Unit or CA Name: POKER LAKE UNIT

Operator: XTO PERMIAN OPERATING
LLC**Notice of Intent**

Type of Submission: Notice of Intent

Type of Action: APD Change

WELL LOCATION INFORMATION

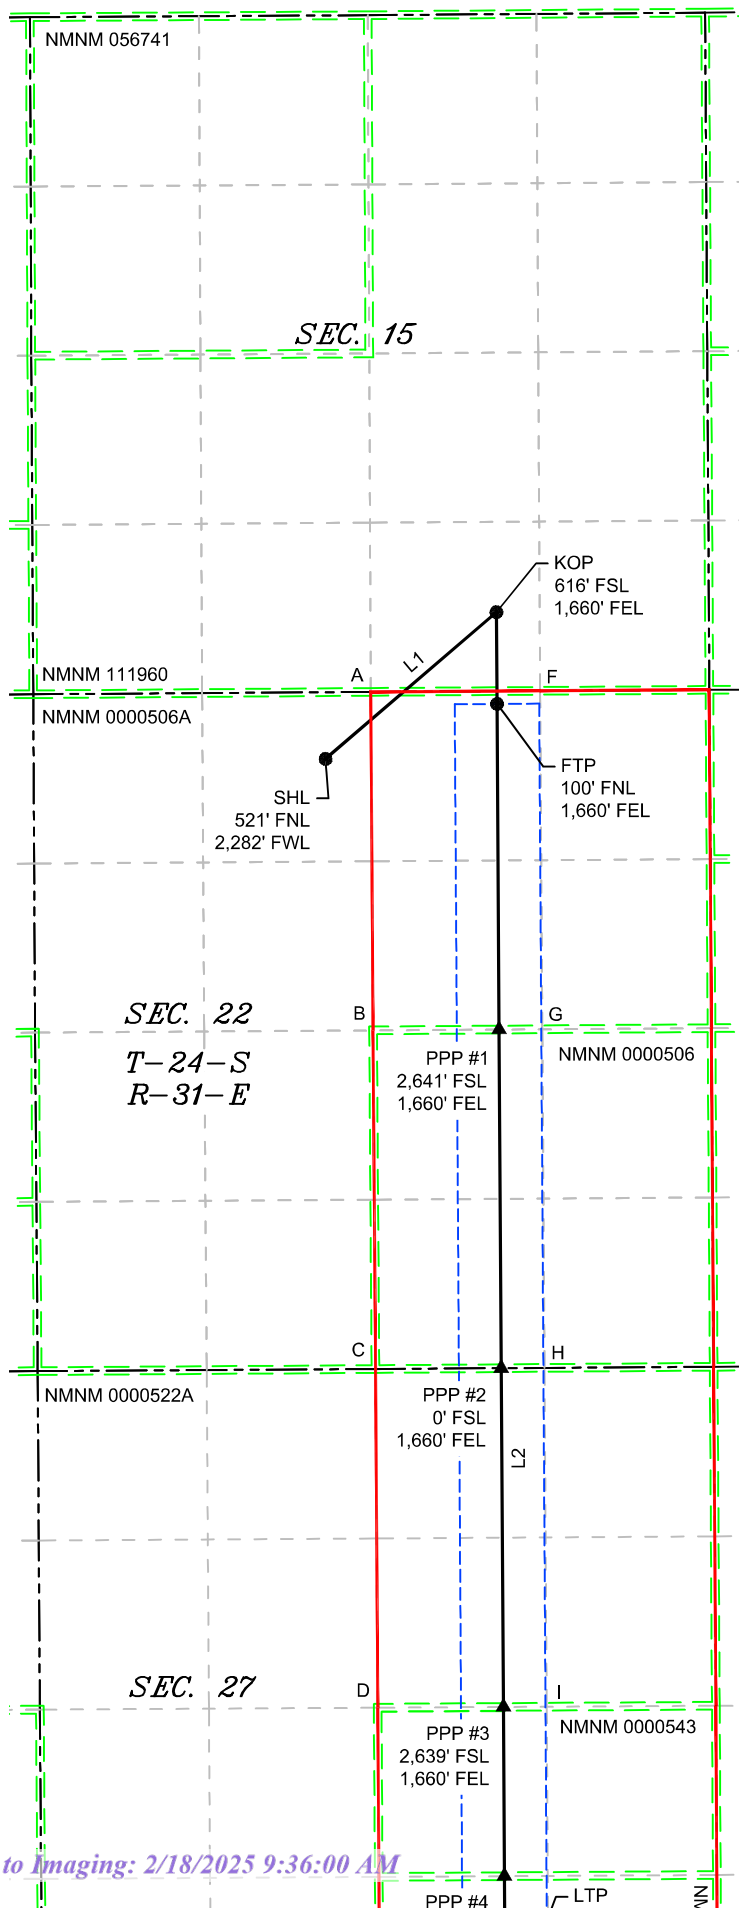
XTO Permian Operating, LLC. respectfully requests approval to make the following changes to the approved APD. Changes to include SHL, KOP, FTP, LTP, BHL, Proposed total Depth, and Pool. There is no new surface disturbance. There is a dedicated change.

FROM: TO:
SHL: 501' FNL & 2282' FWL OF SECTION 22-T24S-R31E 521' FNL & 2282' FWL OF SECTION 22-T24S-R31E
KOP: 501 FNL & 2282 FWL OF SECTION 22-T24S-R31E 616 FSL & 1660 FEL OF SECTION 15-T24S-R31E
FTP: 330' FNL & 2310' FWL OF SECTION 22-T24S-R31E 100' FNL & 1660' FEL OF SECTION 22-T24S-R31E
LTP: 2460' FNL & 2310' FWL OF SECTION 27-T24S-R31E 100' FSL & 1660' FEL OF SECTION 27-T24S-R31E
BHL: 2590' FNL & 2310' FWL OF SECTION 27-T24S-R31E 50' FSL & 1660' FEL OF SECTION 27-T24S-R31E

The proposed total depth is changing from 18027 MD; 10135 TVD to 20040 MD; 8912 TVD.

The pool code is changing from Wildcat; Bone Spring (96403) to Cotton Draw; Bone Spring, South (96546).
